Administrative Approval Action

Case File / Name: ASR-0106-2022
DSLC - Bloomsbury Apartments

REQUEST: Development of a 0.67 acre/29,001 sf tract, zoned DX-20-UL CU. A proposed 20 story mixed-use building with 259 residential units in 411,657 sf. The proposed building includes a 139,912 sf parking deck with 268,305 sf of residential space, 3,265 sf of Restaurant & 175 sf for Personal Services - Dog Wash.

FINDINGS: City Administration finds that this request, with the below conditions of approval being met, conforms to the Unified Development Ordinance. This approval is based on a preliminary plan dated December 8, 2023 by McAdams.

Z1.04

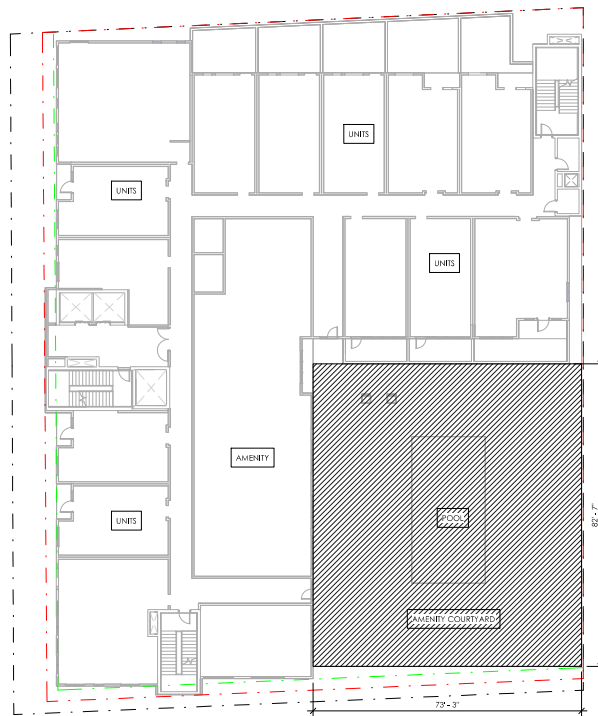
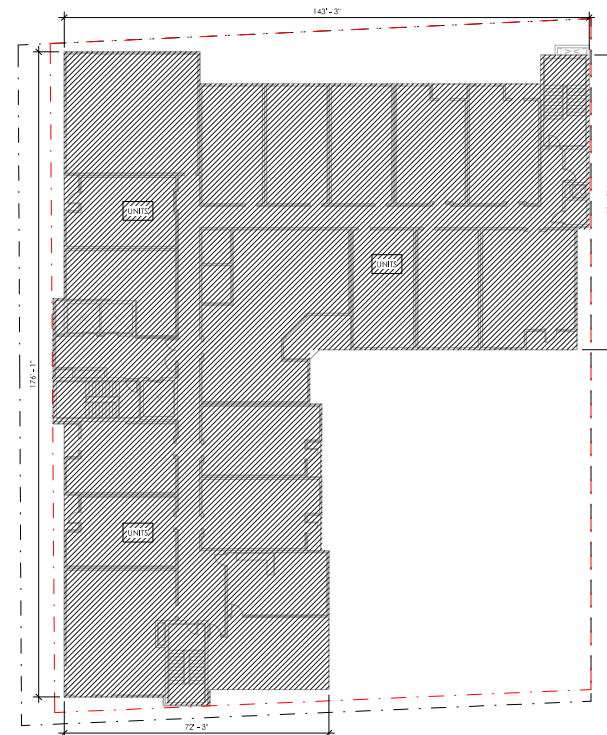
1. Applicant revises the elevation sheets Z4.01-Z4.02 and spot grade the Post-Development grades as shown on the grade table, along Boylan and Hargett St.
2. Applicant updates and demonstrates compliance with the additional amenity design features for Urban Frontages in -DX district, per UDO Sec.1.5.3.C. These features are shown on sheet Z1.04.
